**KAHLE WATER QUALITY BASIN IMPLEMENTATION PROJECT
STATELINE, NEVADA**

The following modifications are hereby made to the Bidding and Contract documents for the above referenced project:

CHANGES TO THE BID DOCUMENTS

ITEM 1: Replace plan sheet D-5 dated March 2018 with plan sheet D-5 dated April 2018 and provided in this addendum. The revised plan sheets contain the following changes:

BASIN OUTLET SECTION A-A

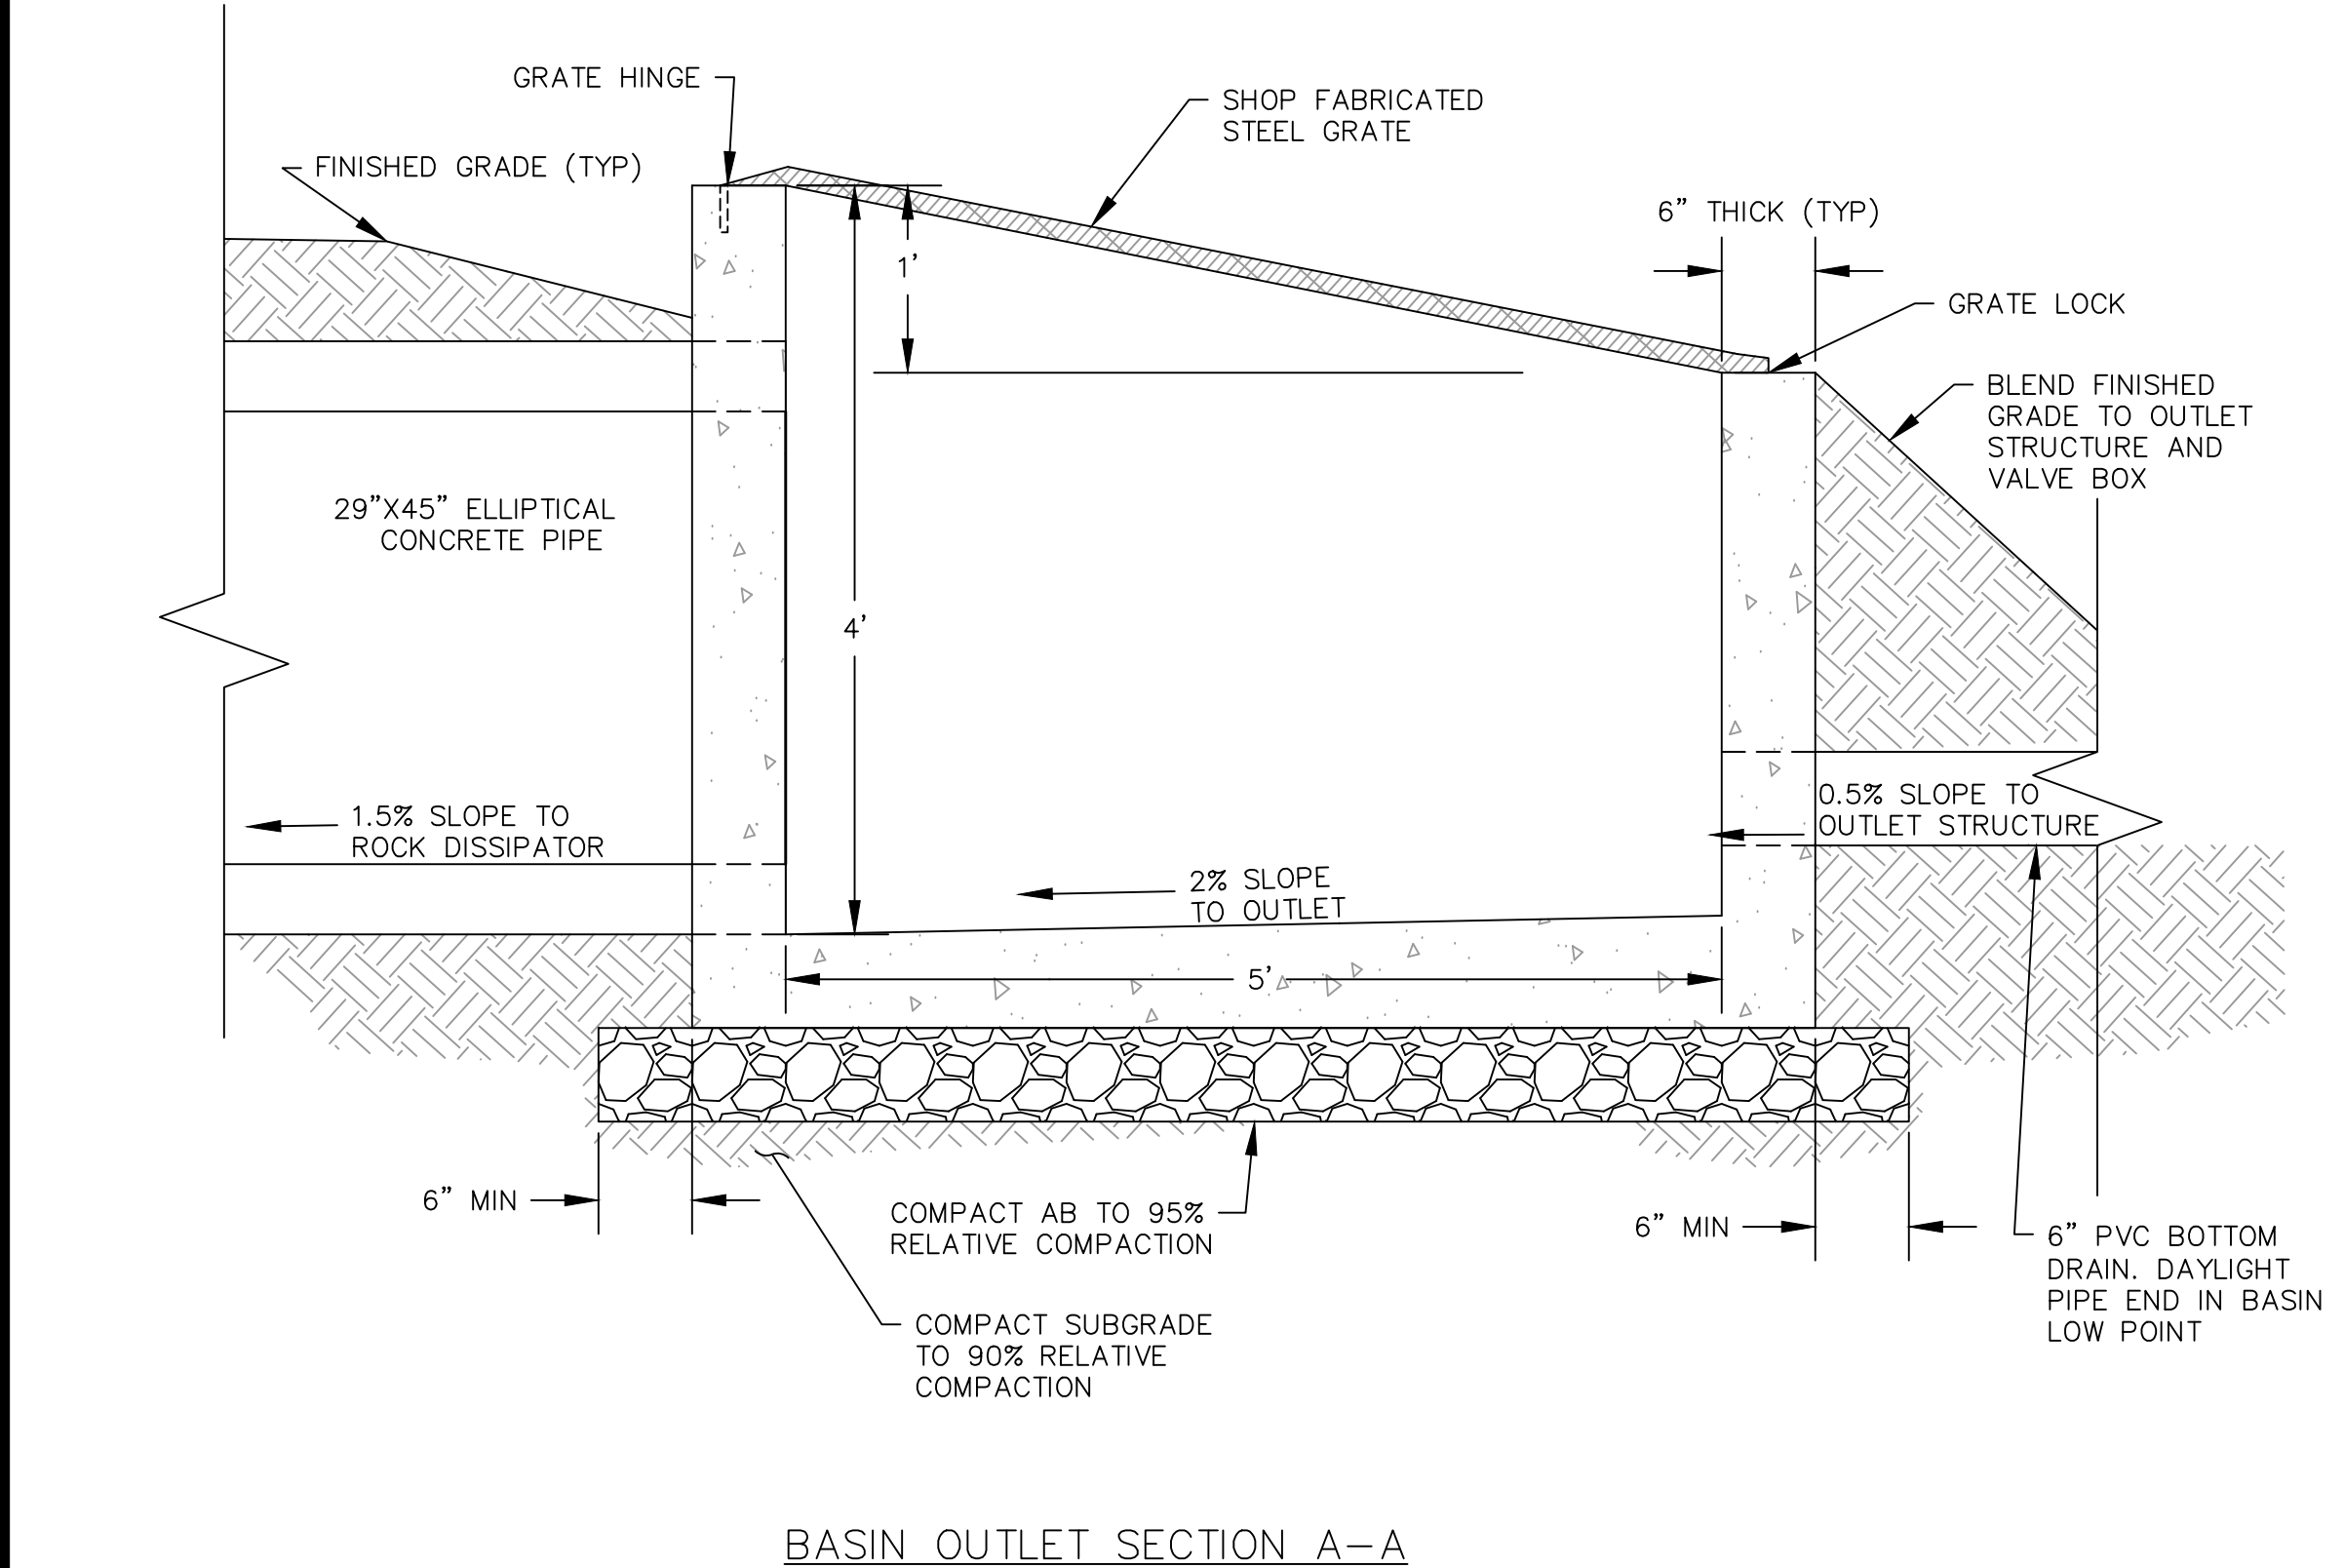
1. In detail 1/D-5 for the Basin Outlet Structure, Section A-A, the aggregate base (AB) should be placed six inches outside the footprint of all sides of the structure. The extents of the aggregate base hatch have been revised to show this.
2. In detail 1/D-5 for the Basin Outlet Structure, detail for the grate has been added. See "Grate Detail" for additional information.
